SB Number:	SB 2H0-001	Creation Date: 17/03/2008
Subject:	Change Ozone filter B (FILTER VOC B) (Support for TVOC)	
Model:	KM-2560/3060/2540/3040

FILTER VOC B (No.1)

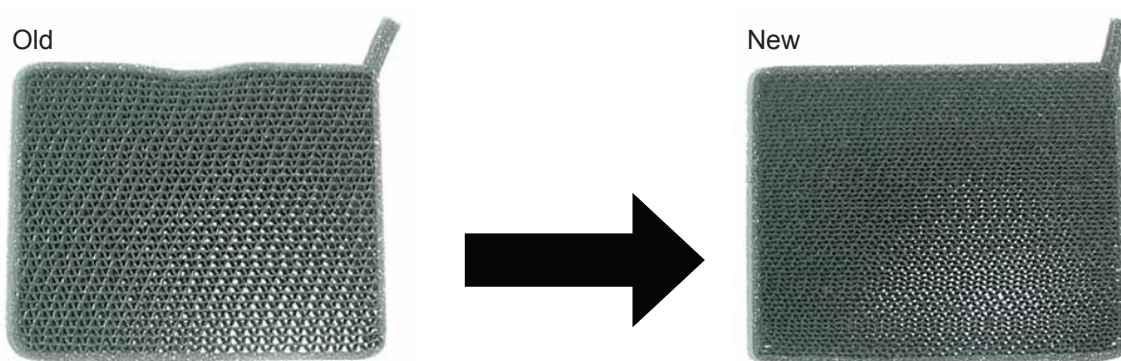
To conform with the new European BAM2007 regulation, ozone filter “FILTER VOC B” (No.1) located at the machines rear side is changed to support TVOC (Total Volatile Organic Compounds). The mesh of the FILTER VOC B (No.1) is smaller then before.

No.	Old Parts No.	New Parts No.	Description	Q'ty		Compat-ibility		SP
				Old	New	Old	New	
1	302H033180 2H033180	302GR33090 2GR33090	FILTER VOC B	1	1	*1	O	O

*1: For machines that do not comply with BAM2007 both the old and new filters can be used.
